Department of Energy
Carlsbad Field Office
P. O. Box 3090
Carlsbad, New Mexico 88221

Subject: Planned Change Notice Regarding Panel 7 Configuration of Transuranic Waste Emplacement

Figure 1 – Generalized plan view of panel 7 and the areas that we are not planning to utilize for Transuranic waste emplacement.

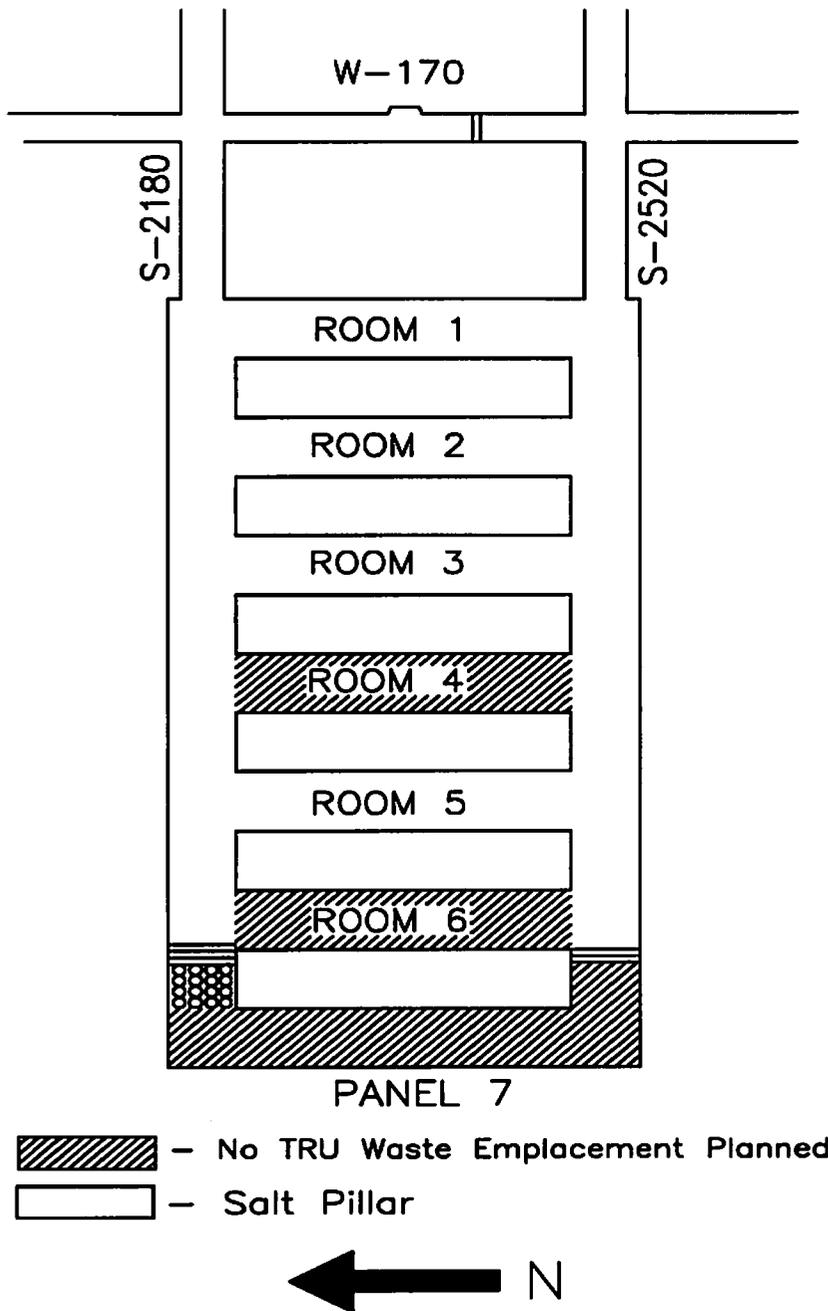
No additional waste will be placed into Room 7 of Panel 7. This disposal room has been closed and isolated by the installation of bulkheads in both the S-2520 drift and the S-2180 drift.

Ground conditions prohibit access to Rooms 4 and 6 of Panel 7 between north of the S-2520 drift and south of the S-2180 drift such that no additional waste will be emplaced in this portion of these rooms. Since resumption of normal operating status on January 4, 2017, CH-TRU waste containers are being placed in the S-2520 drift portion of Room 6 of Panel 7. Magnesium oxide (MgO) backfill will be emplaced in this area based on the calculated mass of cellulose, plastics, and rubber such that an MgO safety factor of 1.2 will be maintained. Additionally, Room 6 of Panel 7 currently includes previously abandoned-in-place, radiologically contaminated equipment. A figure is enclosed that shows the general location of areas within Panel 7 that we are not planning to use for waste disposal (Figure 1).

No additional RH-TRU mixed waste canisters are currently planned to be emplaced in boreholes in Panel 7 at this time. Utilization of the remainder of Panel 7 will be based on geomechanical/ground control considerations to ensure worker safety. The Sandia National Laboratories report dated April 26, 2001, *Panel 1 Utilization Analysis for the Waste Isolation Pilot Plant*, demonstrated this type of change in utilization does not significantly change long-term performance expectations or compromise long-term repository compliance. Based on the April 26, 2001 analysis the same conclusion is made for the change in utilization of Panel 7.
